RISO, INC. **PARTS CHANGE INFORMATION**

PART: SET PLATES / JOB SEPERATOR BRACKETS **ISSUE #: 020**

JAPAN: TI-050

011-13144 Set Plate F; P-Rcv-T
011-13146 Set Plate R; P-Rcv-T

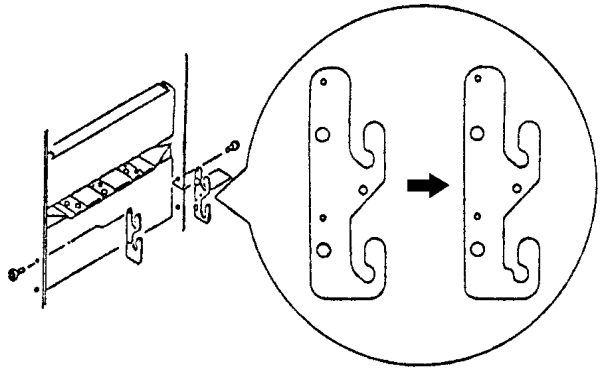
The Set Plates and Job Seperator Brackets have been changed to allow a 45 degree tilt to the Receiving Tray. The new parts improve paper stacking in the Receiving Tray.
